# River Run Unit Two Replat "A"

City of El Paso — City Plan Commission — 2/7/2019

**SUSU19 - 00003 — Resubdivision Combination REVISED**

## **ATTACHMENT 3**

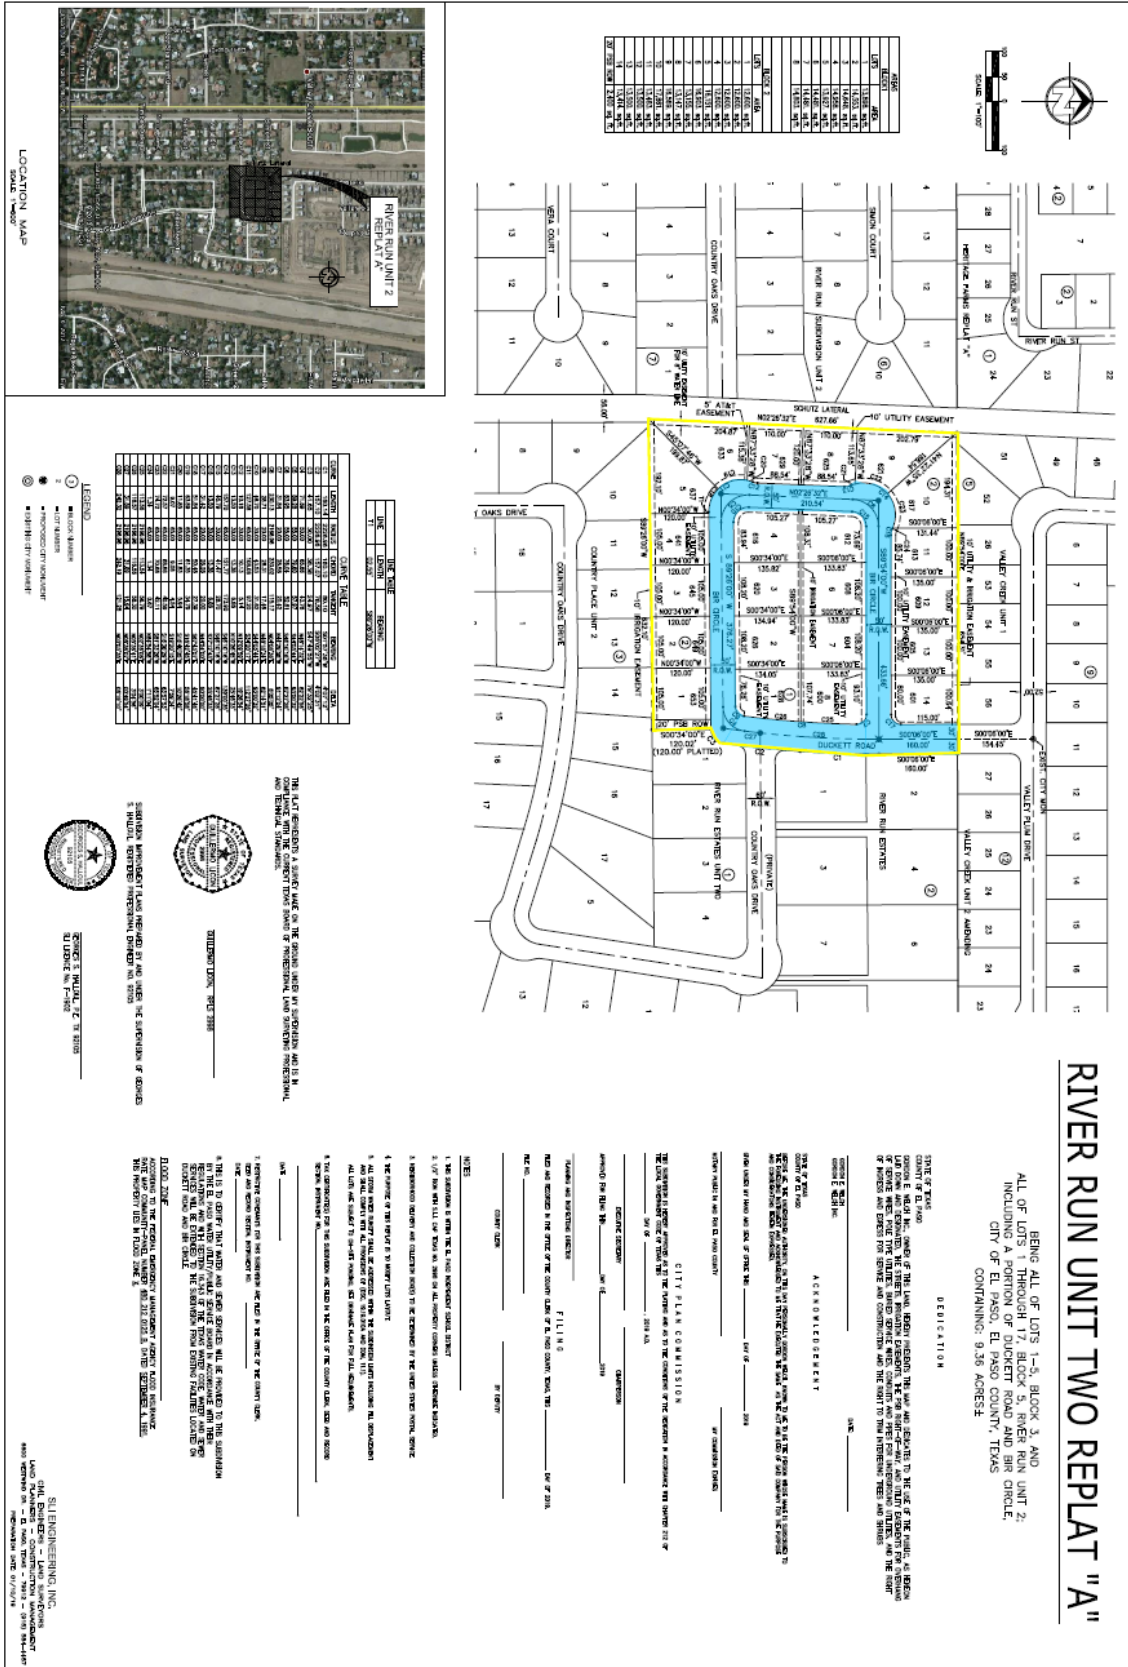
- 1. Note #5 should read: "...and shall comply with all provisions of Muni-Code Section #19.19.1a, DSC panel 1-4C, and DDM section 11.1".
- 2. At the improvement plan stage, protect the subject property from storm water runoff from the adjacent terrain.
- 3. Remove pavement thickness values on typical street cross sections.

Change Block 1 to Block 10 and Block 2 to 9.
